# Providence City Plan Commission

## AGENDA ITEM 2 ■ 663 ADMIRAL STREET

### OVERVIEW

Ground floor site plan

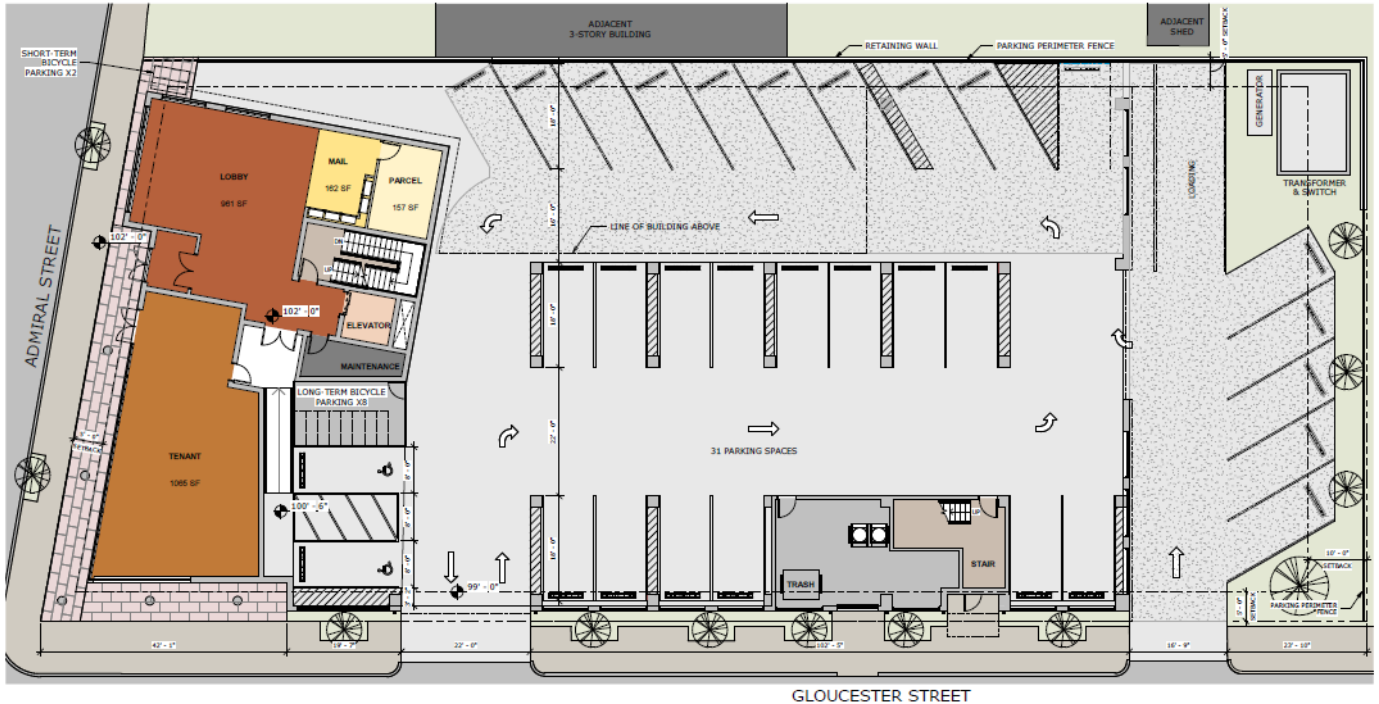
The site is located at the corner of Admiral and Gloucester Streets and will measure approximately 21,026 SF upon merging of the subject lots. Ground floor commercial space will be located at the corner of Admiral and Gloucester Streets with the rest of the ground floor occupied by a lobby, mailroom, bike parking, elevator and stairs. Pedestrian and vehicular access to the parking area which includes a loading space and the transformer, will be provided on the area occupied by lot 171 and accessible from Gloucester Street. This portion of the development will not exceed 65% pervious surface limit of the R-2 zone. A total of 31 vehicle parking spaces will be provided. A dimensional

The applicant has requested a parking adjustment to provide 31 spaces where 48 are required, calculated as one space per dwelling unit. The commercial space is exempt from providing parking as it measures less than 2,500 SF in the C-1 zone. The vehicle and bicycle parking area will be provided on the ground floor to the rear of the commercial area and lobby. The parking area will be accessed from Gloucester Street with the loading zone and transformer located in the northern portion of the access area. Standard parking spaces will measure 8.5' x 18' and compact spaces will measure 7.5' x 15' which will meet the parking space dimensions required by the ordinance. Drive aisles of 22' and 16' will be provided for non-angled and angled parking respectively.

Part of the area corresponding to lot 171 is paved to provide access to parking. The rear of the lot will be treated with permeable pavers for the loading area and crushed stone for the location of the transformer. The applicant is proposing to meet the canopy coverage requirement by providing street trees along Admiral and Gloucester Street and by making plantings in the parking area. A detailed landscaping plan is forthcoming as a waiver from submission of a detailed landscaping plan has been requested. The CPC should grant the waiver subject to the condition that a landscaping plan shall be subject to the Forester's approval prior to the final plan stage.
